RE: REVISED ENGINEER CERTIFICATION FOR FINANCIAL GUARANTEE RELEASE  
FOR NOR-ESTE MANOR BLOCK F (C19-D6B1) ENGINEER CERTIFICATION  
STATEMENT DATED 5/5/94.

EROSION STUDY  
NORTH DOMINGO BACA ARROYO  
AT  
NOR ESTE MANOR, BLOCK F AND TRACT "B"

ADDENDUM NO. 1  
TO THE  
EROSION STUDY  
NORTH DOMINGO BACA ARROYO  
AT  
NOR ESTE MANOR, BLOCK F AND TRACT "B"

Re: Erosion Study North Domingo Baca Arroyo at Nor Este Manor,  
Block F, and Tract "B" (Revised April, 1990)

### TYPICAL SECTION - SEGMENT 1

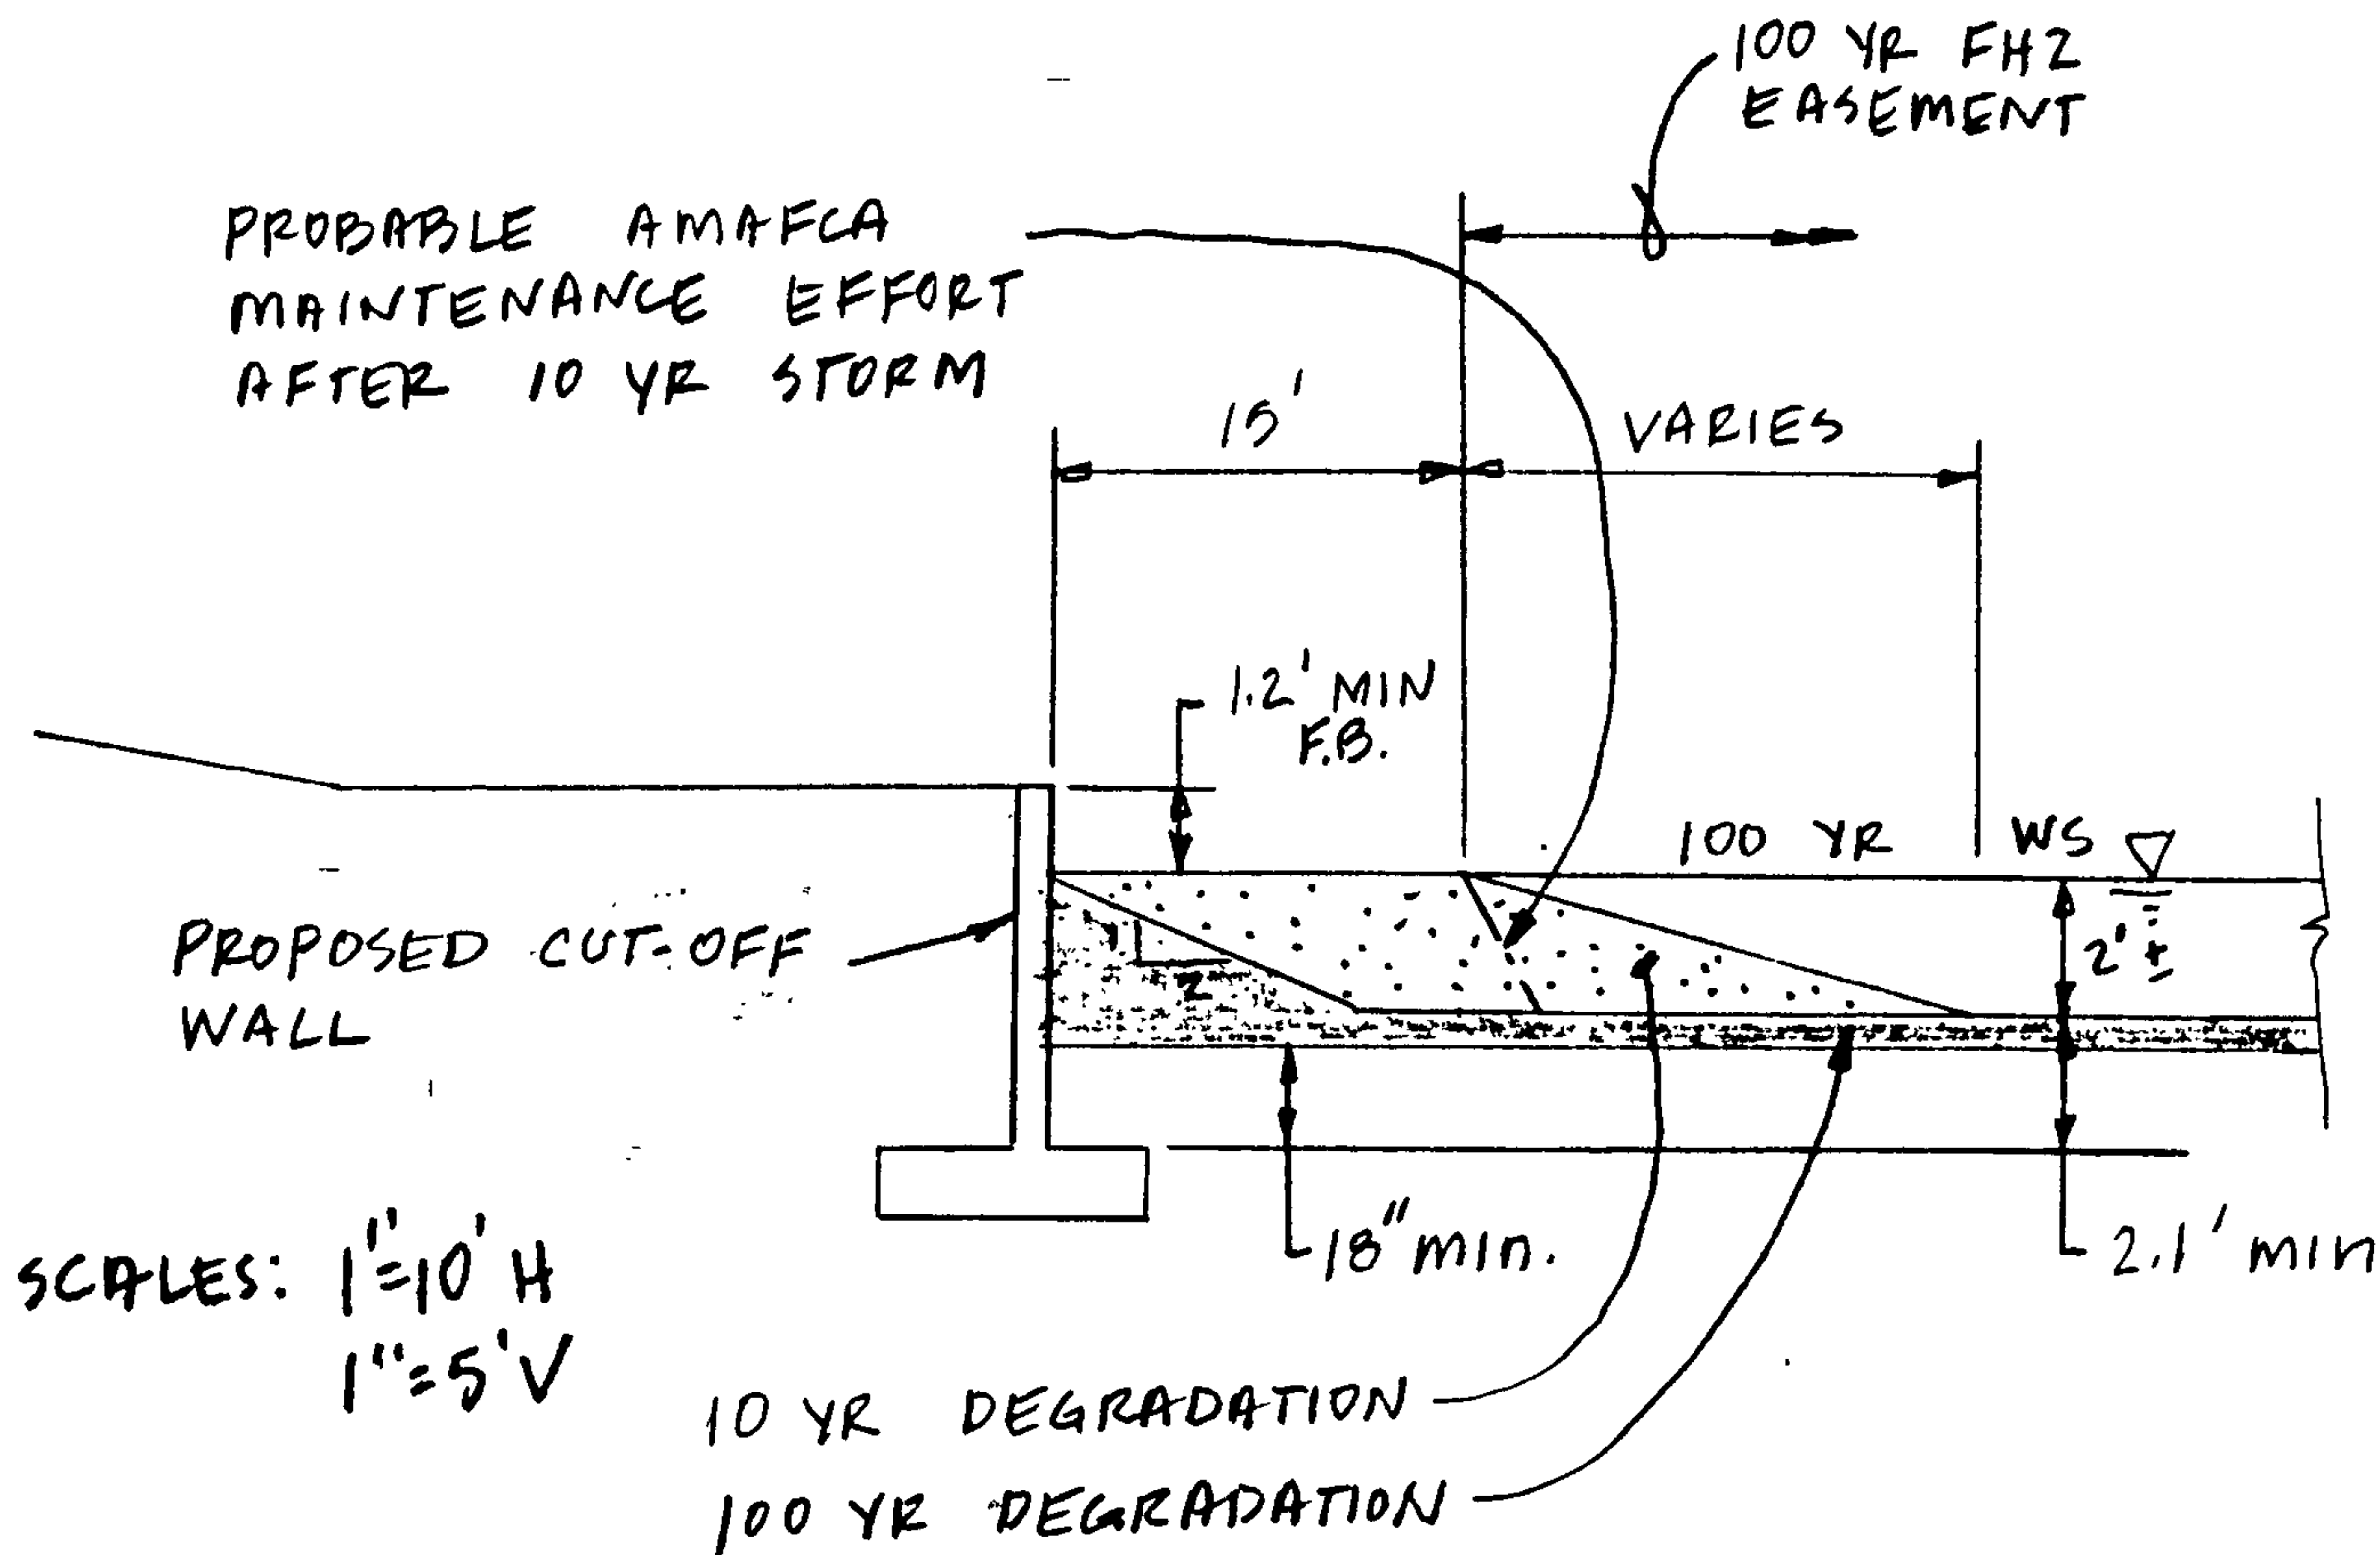
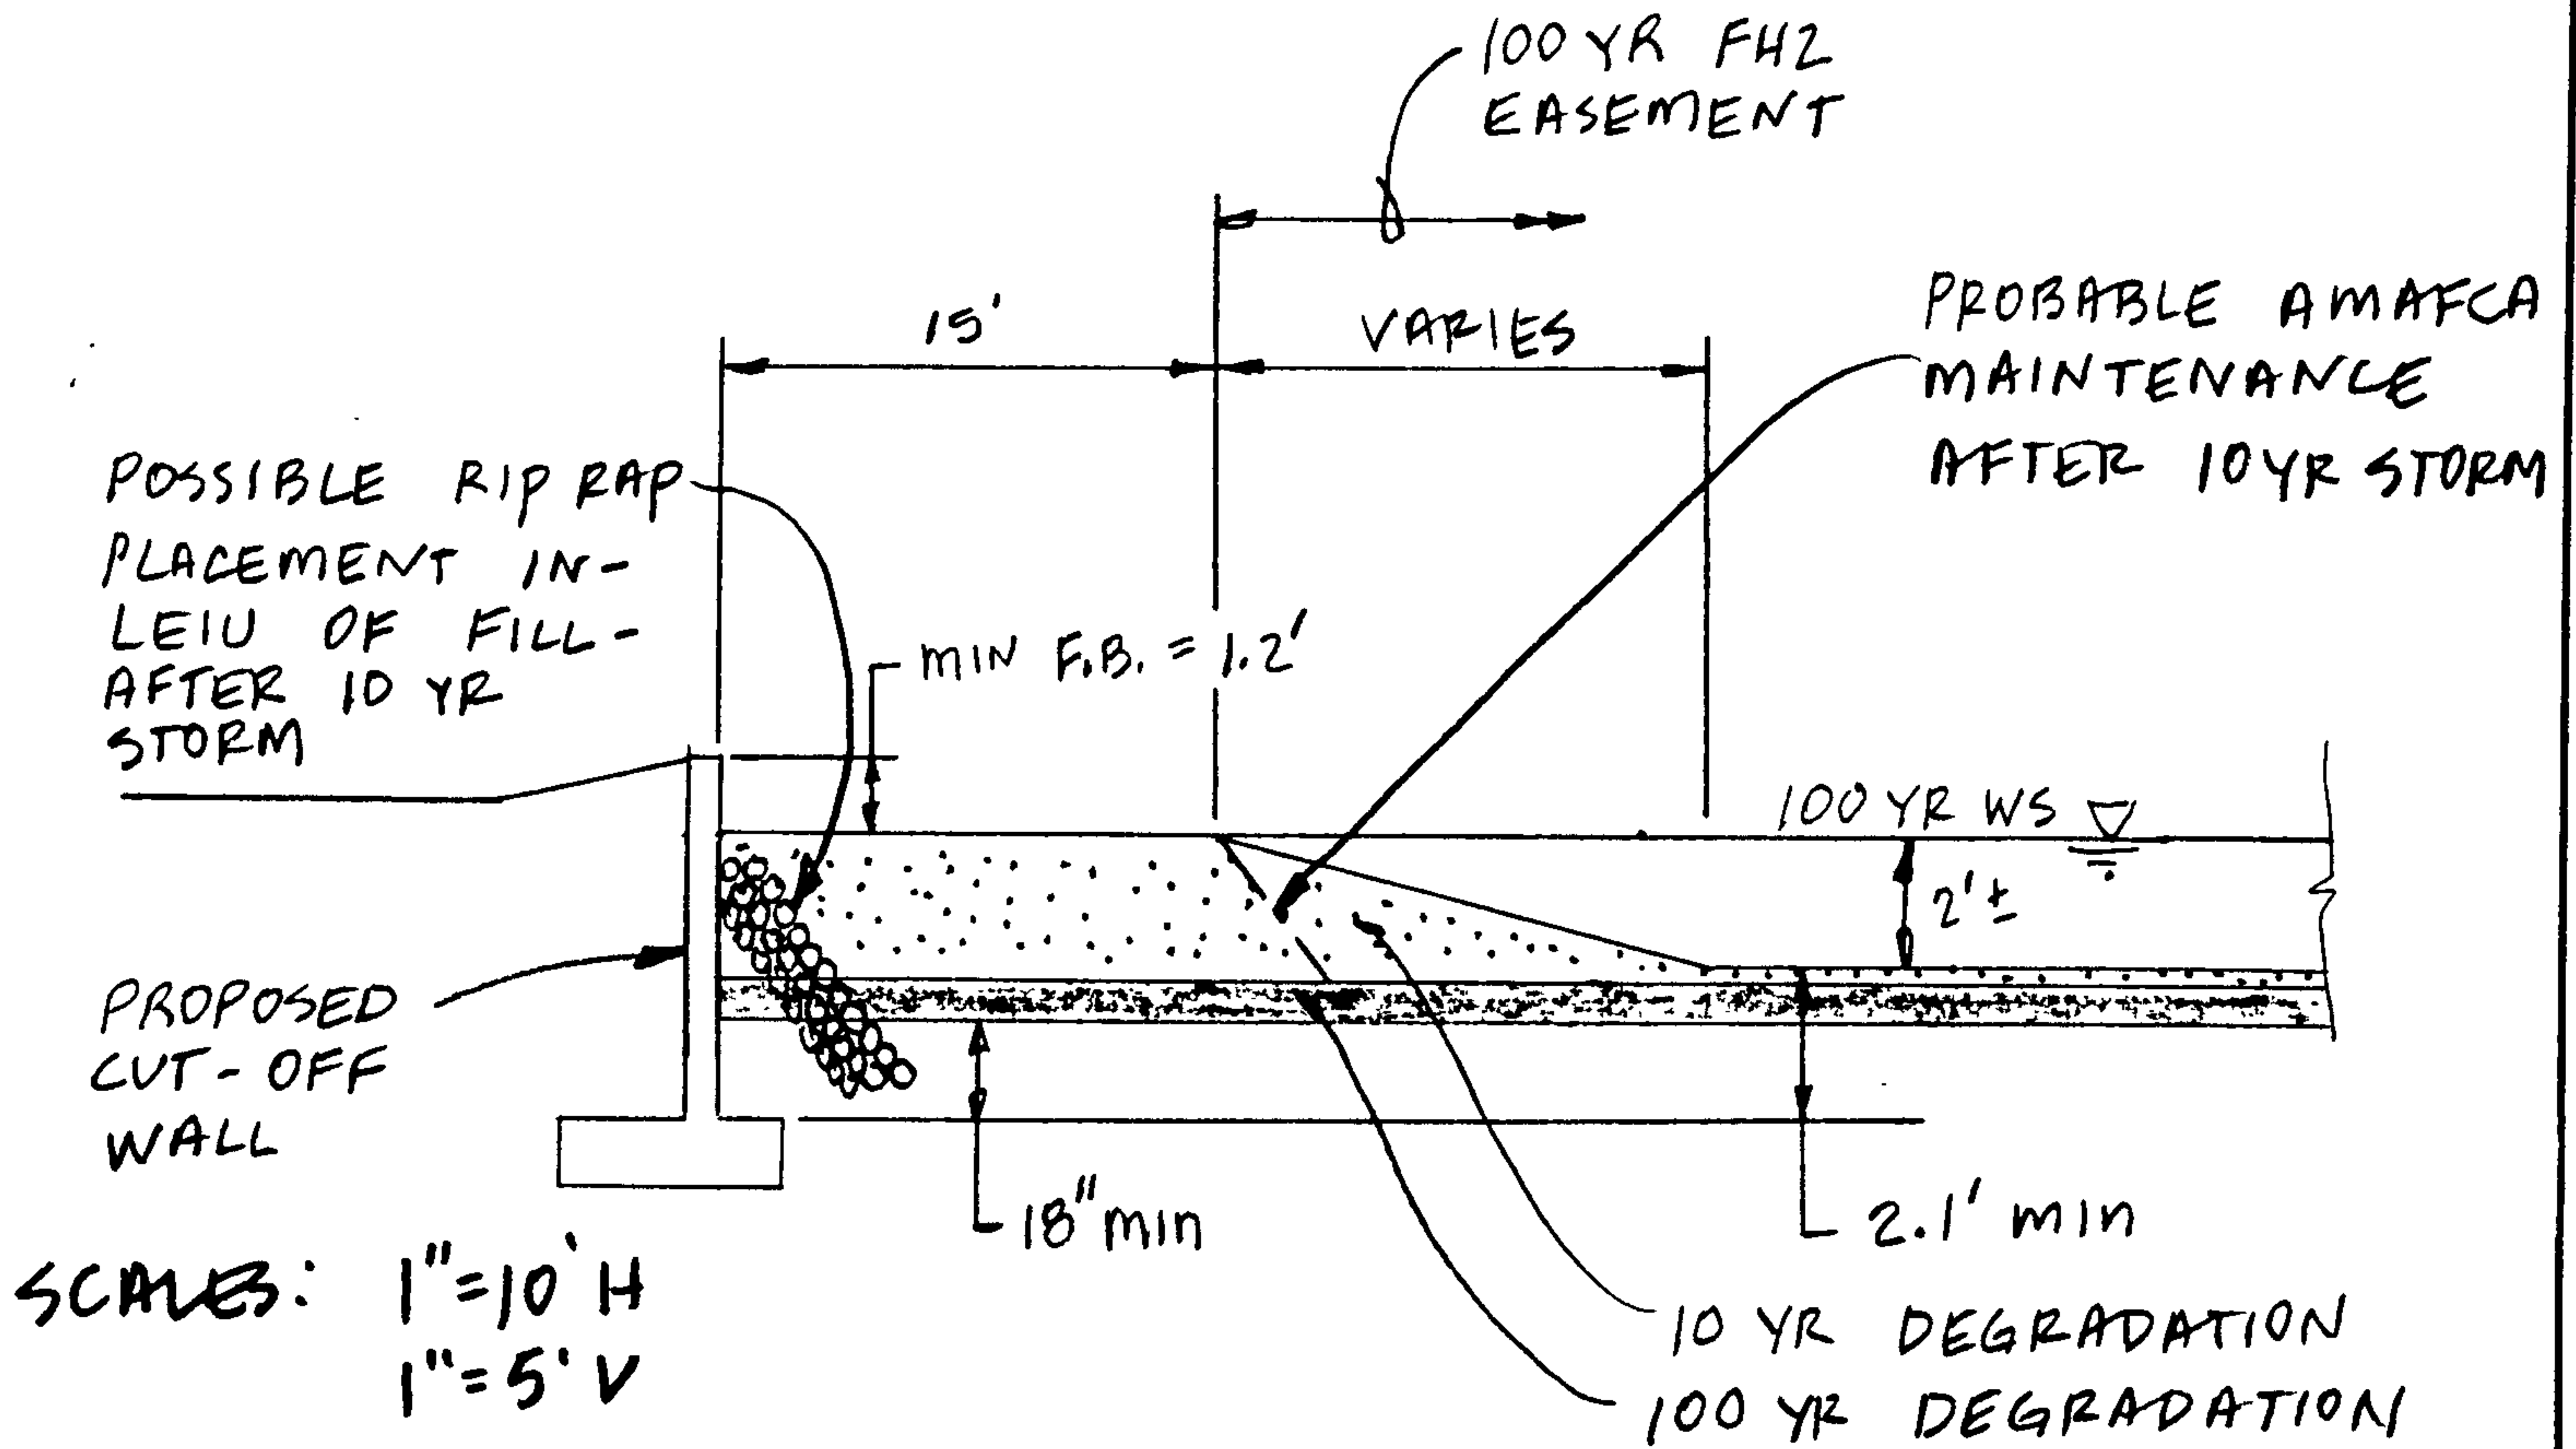
As in the original report, the cutoff walls have been designed considering only degradation. In Section V of our March 13 letter we discuss the need to account for other components of scour, such as low flow incisement and local scour, in designing cutoff walls. These concerns and recommendations remain unaddressed and limit the integrity of the proposed design.

Additionally, it is not entirely clear from the calculation sheets how the scour depth was computed, which relates directly to the above comment on the lateral distribution assumptions. Regardless of the method, we are concerned that the proposed cutoff walls will only be about 2.0 feet below the existing arroyo bottom. With such a minor amount of toe-down, it will not take much erosion to undermine the wall. Such erosion could easily occur in localized reaches, possibly resulting in wall failure over longer reaches. Considering the dynamic nature of arroyo channels, as an absolute minimum, we would recommend a toe-down of 3 feet, which we still feel to be somewhat risky with little or no safety factor. In similar situations, design of toe-down for riprap bank protection often results in a recommended burial depth of 4 to 6 feet.
